Date: November 15, 2007

## Product Change Notice: XPort Firmware Version 6.5

Lantronix is pleased to announce the launch of the updated and improved version 6.5 XPort firmware.

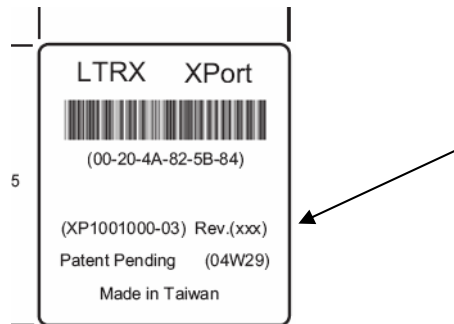
For quality and tracking purposes, the manufacturing revision numbers on the product label will be changed. New revision numbers are also listed in the table.

Please note that the revision information for the XPort product is on the label in the location shown below:
